**Reference** 22/2781/MOUT

**Location** Land Adjacent To Harepath Road Seaton Devon EX12 2WH

**Proposal** Outline planning application (with details of access to be considered and all other matters reserved) for mixed use development comprising of up to 130 dwellings to the east of Harepath Road and the laying out of a new community football pitch, parking and welfare facilities to the west of Harepath Road, formation of accesses on Harepath Road and Colyton Road, public open space and other associated infrastructure.

### RECOMMENDATION: Approval with conditions

*Copy of landscape recommendations presented as figure 4.10 in applicant's submitted landscape and visual appraisal*

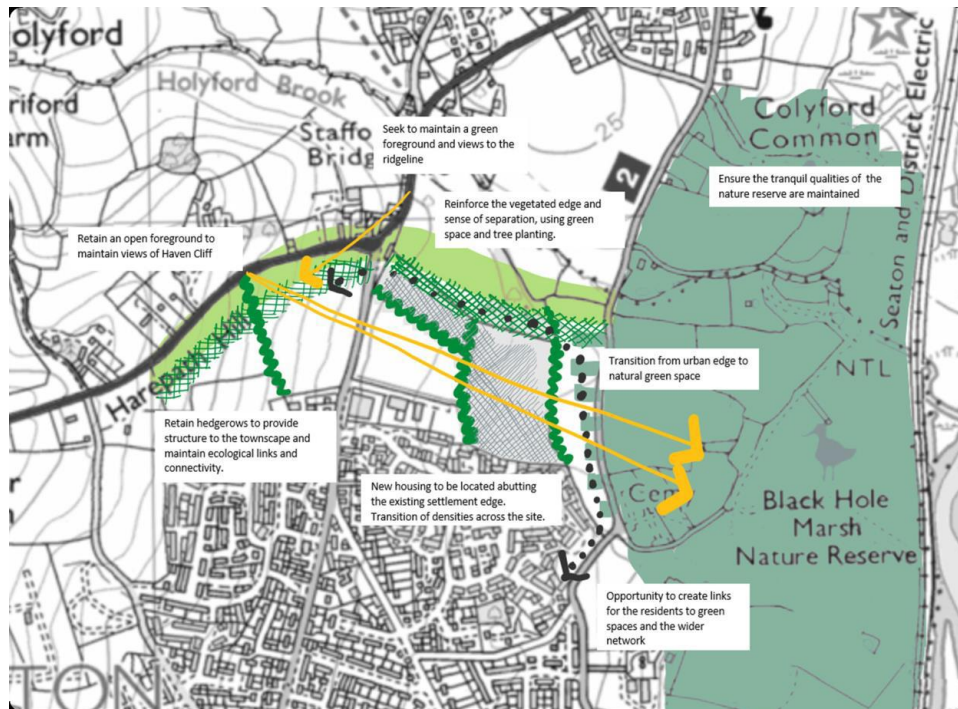
5 The LVIA submitted with the application included as figure 4.10 a plan (copied below) illustrating landscape recommendations '*based on the published analysis and site observations to be considered in the development of the masterplan*'. For the above reasons I concur with the indicated recommendations that development should be concentrated in fields 2 and 3 and that all existing hedgerows should be retained.

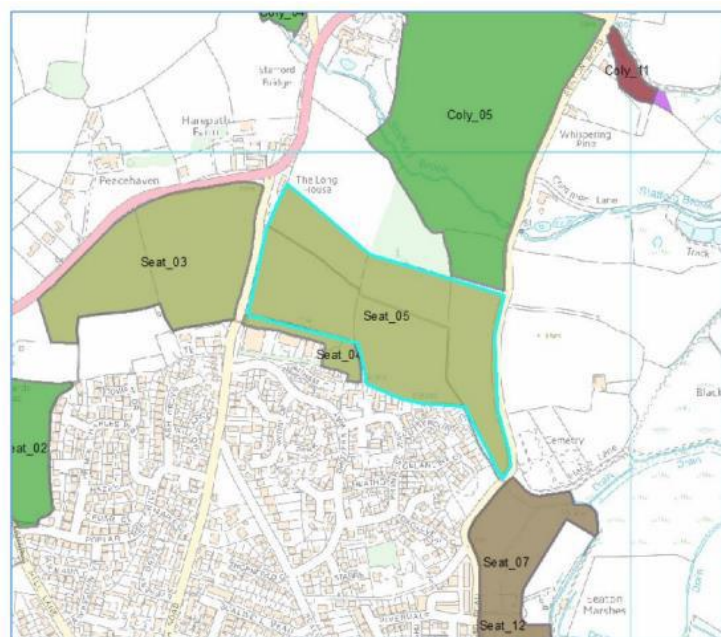
The proposed outline plan indicates that approximately 220 m of species-rich hedgerow (H12) would be removed from the site, as well as 20 m of species-poor hedge (a Priority Habitat).

H12 is considered important under the Hedgerow Regulations 1997, is a Devon Biodiversity Action Plan (DBAP) habitat, and a habitat of Principal Importance (NERC Act, 2006). In addition, the hedgerow is used as a commuting route used by qualifying species (lesser horseshoe and myotis bats) associated with Beer Quarry and Caves Special Area of Conservation (SAC), is assumed to be used by hazel dormouse, reptiles, common amphibians, nesting birds (including red listed<sub>1</sub> and Priority Species Linnet and amber listed White Throat), and is a historic hedgerow shown on 1890s OS maps.

Given the ecological value of this historic hedgerow, including its confirmed use as a commuting route used by qualifying species associated with Beer Quarry and Caves SAC, it is unsure how the mitigation hierarchy has been followed using reasonable avoidance in the first instance and retaining this hedgerow within the development, even if the value of the hedgerow is reduced for foraging and commuting light adverse bats due to the proximity of the development. Historic Devon hedge banks provide multiple ecosystem services and habitat for a range of protected and notable species. The retention of existing linear features
